Road & Bridge Design Publications

Monthly Update – December 2023

Revisions for the month of **December** are listed and displayed below and will be included in projects submitted for the **April** letting.

R-56-F

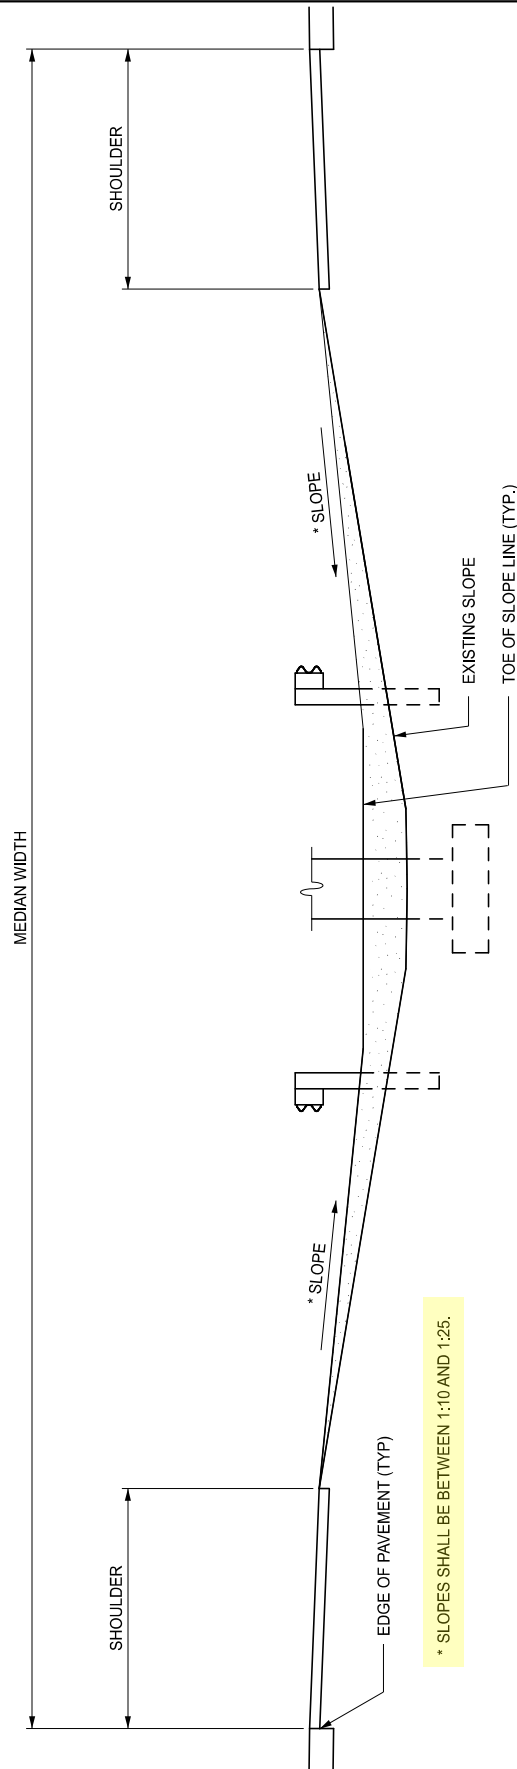
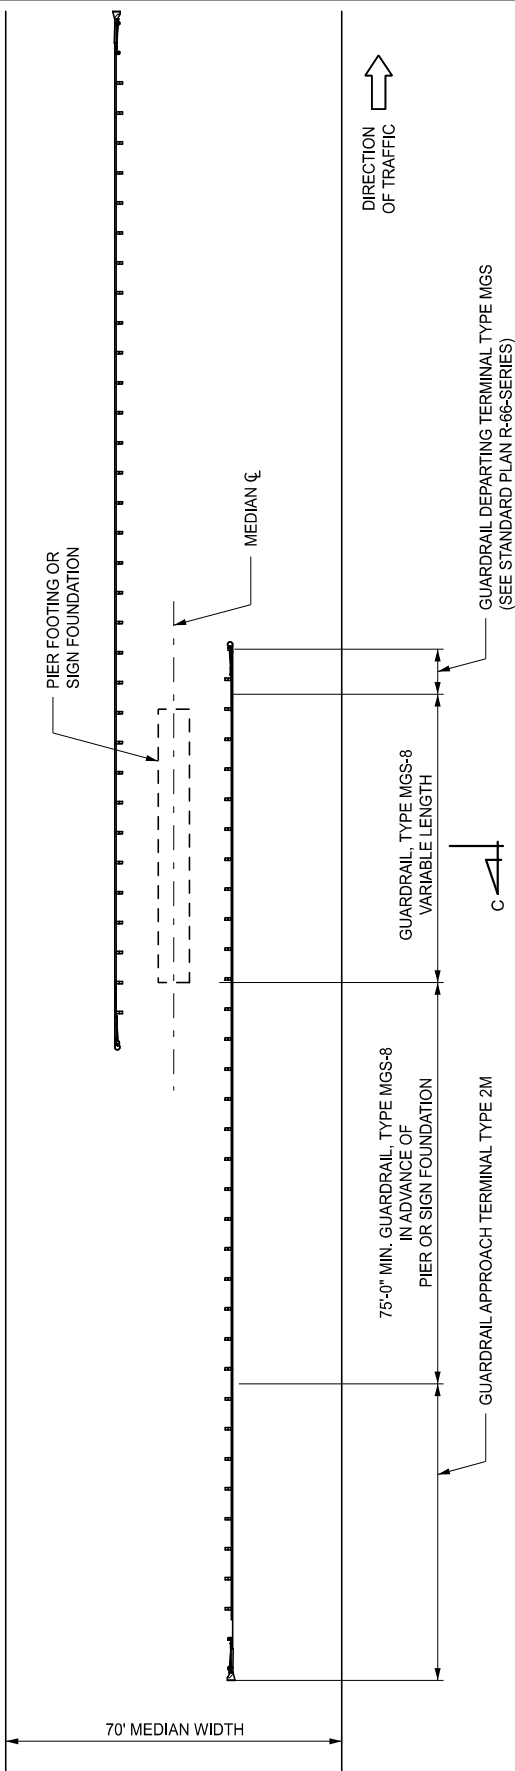
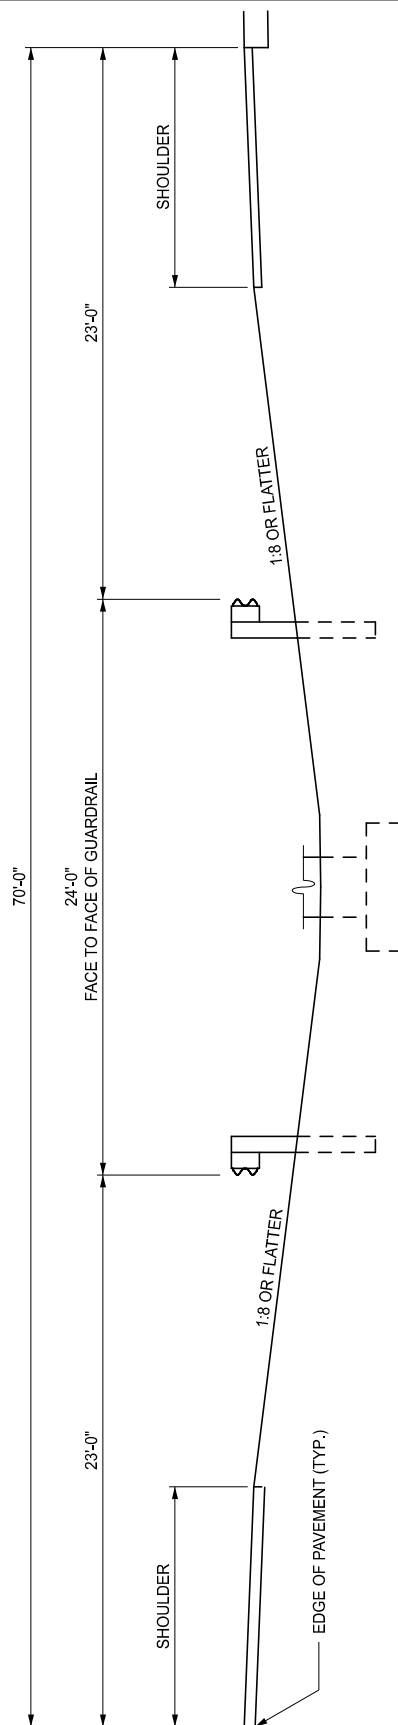
R-56-F: Guardrail Median Object Protection: Revised the details to include the use of the new Type 3M terminals instead of the Type 3B & Type 3T terminals. Also revised the median grading requirements (regardless of width) to slopes between 1:10 & 1:25.

SHEET
10 OF 16

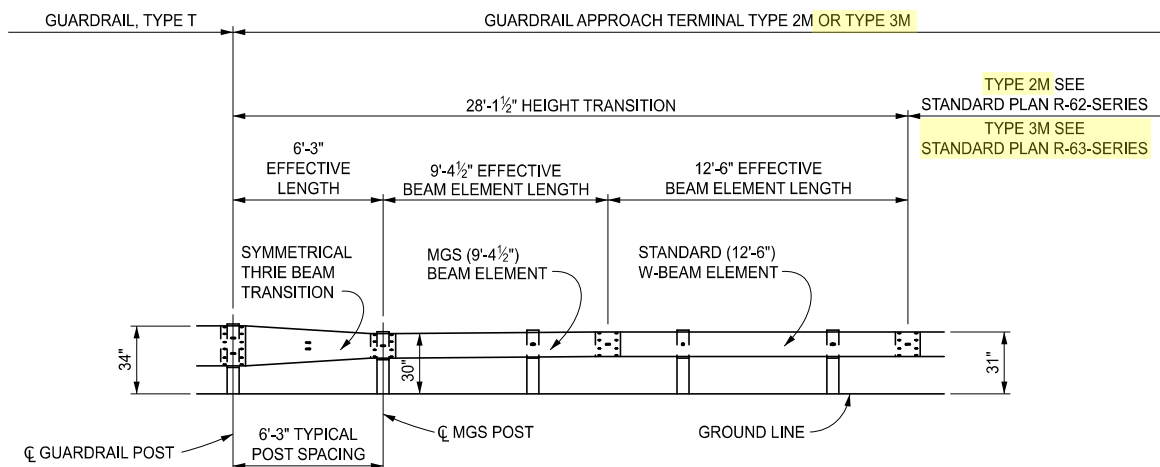
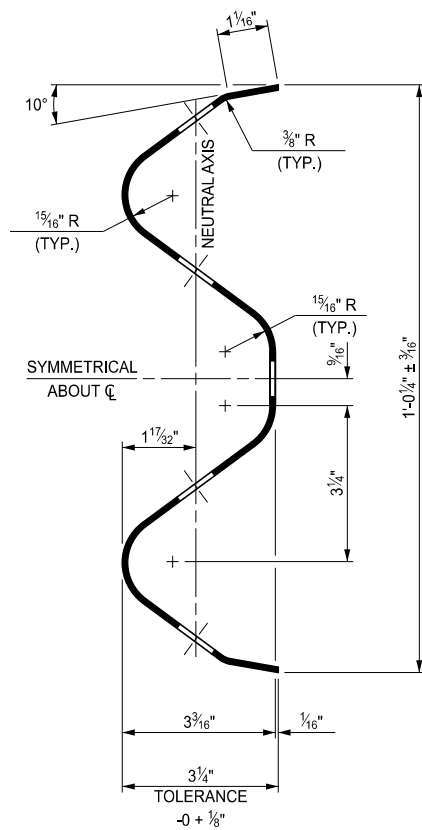
R-60-J: Guardrail Types A, B, BD, T, TD, MGS-8, & MGS-8D: Modified the transition details on sheet 10 to specify attaching Type B or Type T guardrail to both Type 2M terminals and the new Type 3M terminals.

R-63-C

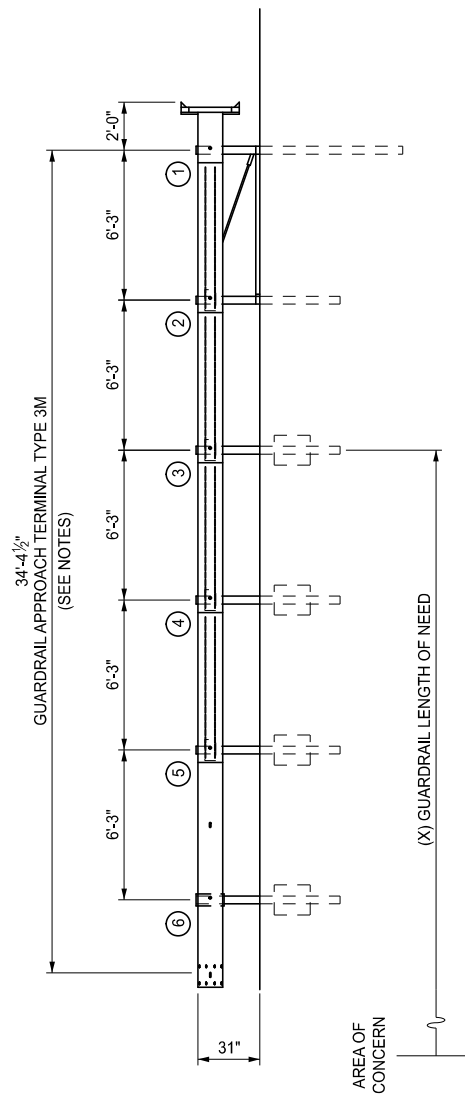
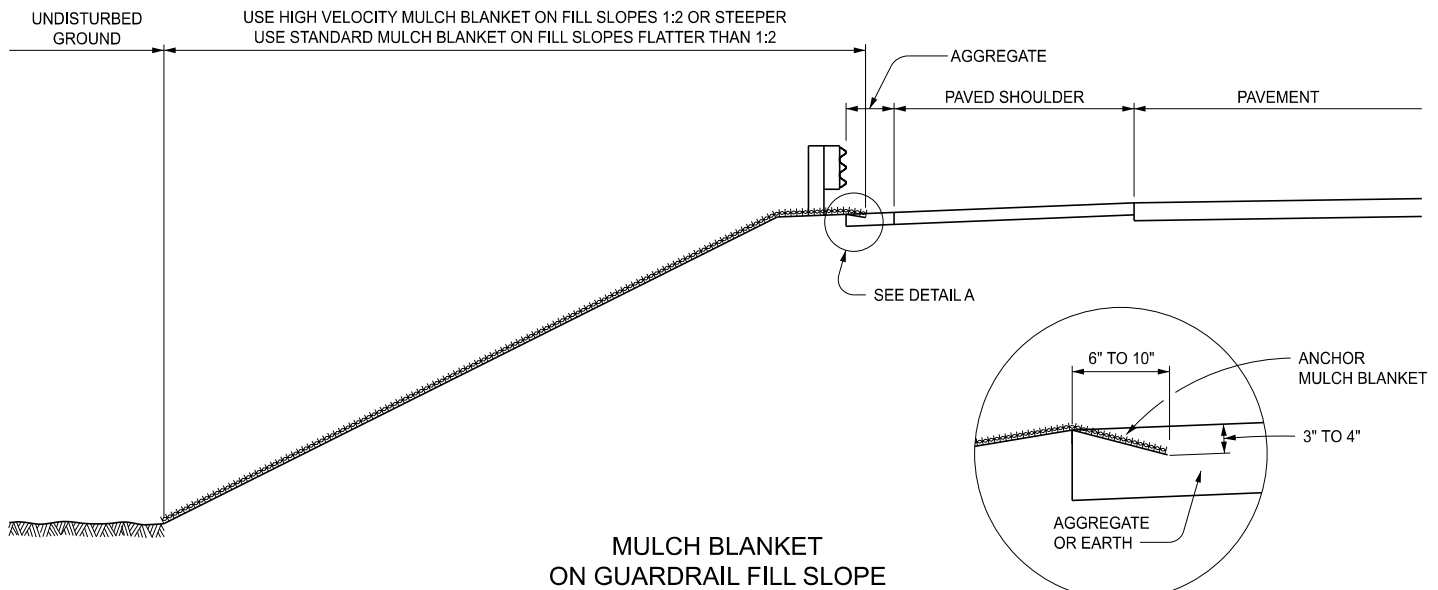
R-63-C: Guardrail Approach Terminal, Type 3M: Eliminated the Type 3B & 3T terminals in favor of two MASH approved (Type 3M) terminals. The information contained on this detail will supplement what is contained in a recently released FUSP and the manufacturer's drawings for this terminal type. Designers will need to call for both the special detail and the FUSP when a Type 3M terminal is required.

R-100-I

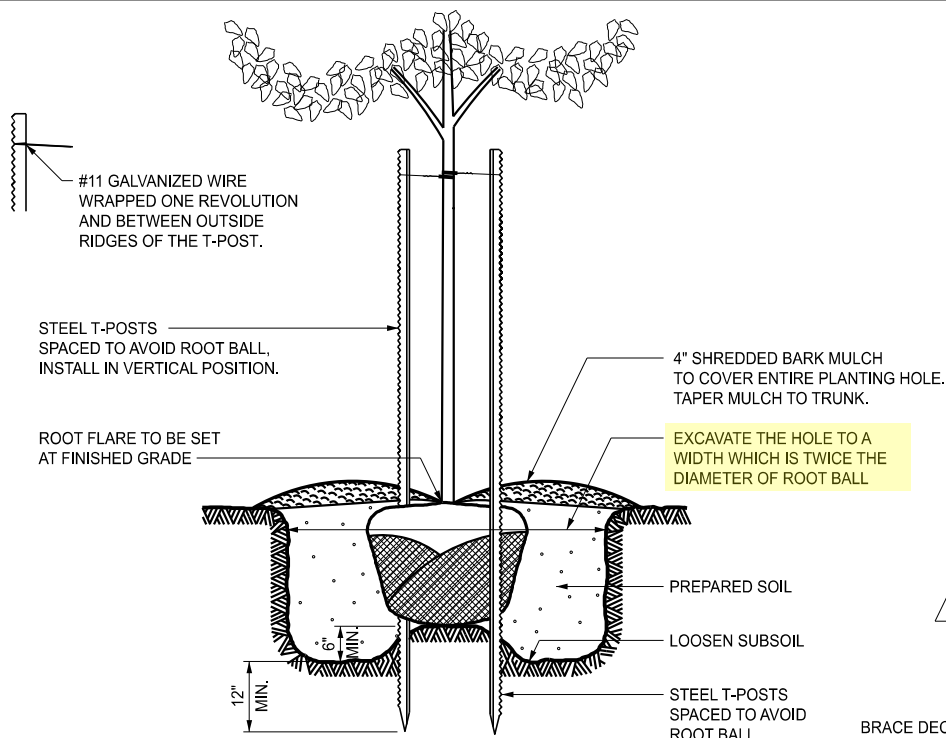
R-100-I: Seeding and Tree Planting: Revised the excavation area from 1.5 times the size of the root ball per side to 2 times the size of the root ball in total.
